**From:** Price, John E [<mailto:jeprice@STPEGS.COM>]  
**Sent:** Friday, August 24, 2012 1:07 PM  
**To:** Tai, Tom  
**Cc:** Chakravorty, Manas; Chakrabarti, Samir; Thomas, Brian; Head, Scott; Mookhoek, William  
**Subject:** Section 3.7 & 3.8 Actions - Updated August 15, 2012

Punch List for South Texas Project Units 3 & 4 - Post February 2012 Audit  
 Sections 3.7 & 3.8 - Post February 2012 Audit

# Discussion of Cutoff Frequency

Figure 1 - Normalized Cumulative Power Spectral Density of the Design Time History

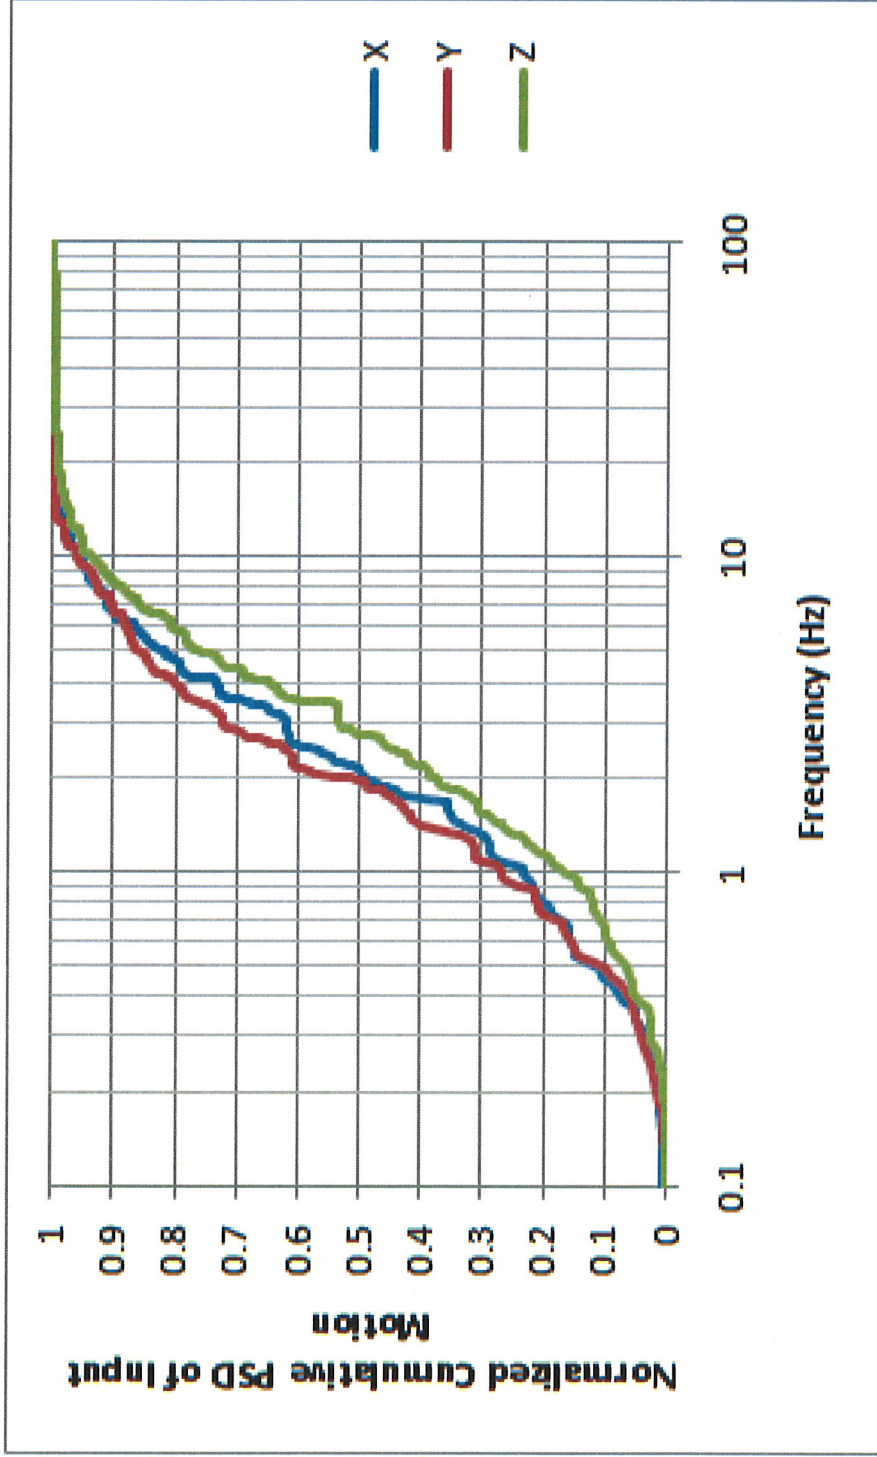
Regarding new Punch List Item 274 on Manas' question for the frequency content of the time history, I have attached relevant pages from our August 4, 2010 meeting presentation. This material did not get into any RAI. A more refined model was subsequently developed to resolve the Staff's concern. Thus, all RAI responses present the results with a more refined model.

274	8/15 Phone Call	Provide document reference for the energy content in the time history used for the Control Building Benchmarking SSI analysis using MSM	N/A	8/6/12	Will respond via e-mail
275	8/15 Phone Call	Respond to Staff need for Design Basis Hurricane Wind and Hurricane Missile Evaluation	N/A	TBD	Will discuss plan at the 8/22 Conference Call

- The minimum cutoff/passing frequencies in a SSI analysis depend on the following:
  - Frequency content of input motion – For UHS 98% of the input motion energy is below 15 Hz frequency
  - Primary SSI frequency – The SSI frequency of UHS is below 5.6 Hz
  - Structural frequencies – Major UHS modes are below 15 Hz
- The industry standard (ASCE 4-98) for cutoff frequency is twice the SSI frequency but not less than 10 Hz
- The minimum passing frequency and cutoff frequency used in the analysis is 15.2 Hz (at the base of the UHS) and 16.6 Hz, respectively, which meets the above requirements.
- The minimum passing frequency for the excavated elements at top of the soil level for Lower Bound case is 10.7 Hz. However upper excavation level element size is not important since the slab is horizontally rigid, most motion is acted at foundation level and subtraction method is used.
